**MEETING TITLE:** City of Seguin – Cordova Rd Reconstruction      **DATE:** 09/15/2023  
 30% Review Meeting

**PROJECT NUMBER:** 12775-00

**Meeting minutes, discussions, and action items are shown in bold**

Table 2-3: Minimum Radii and Superelevation Rates<sup>1</sup> for Low-Speed Urban Facilities

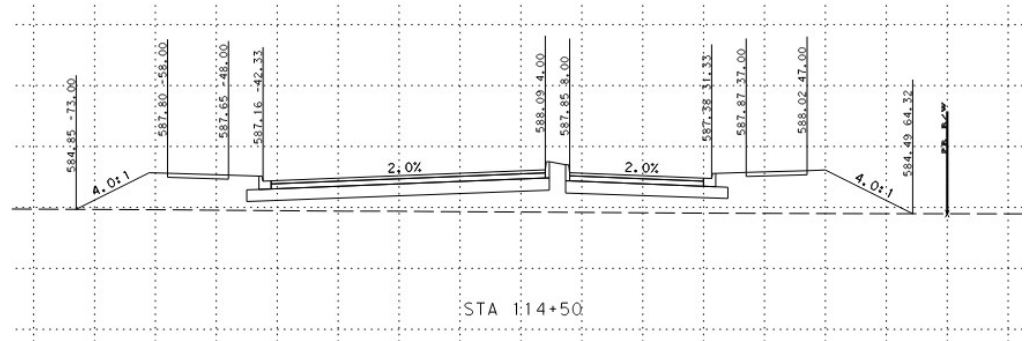
- 2) TxDOT Comments
  - a) Primarily information added with future submittal (traffic signals, sidewalk details, detailed curb ramps, etc)
  - b) Turn lane taper lengths- criteria for 40 mph is 50', TxDOT recommends 100'- CoS preference?

- c) Super elevation
    - i) CoS criteria for 40 mph is 770' min radius with no super- this meets TxDOT/AASHTO for low speed urban with no super. RDM table 2-3

- ii) TxDOT continues to request super elevation

- iii)
- iv) Requested removal of curb and gutter (curb)- maintaining curb and gutter per CoS criteria
- v) Requested vertical curves for 1% grade break- meets criteria
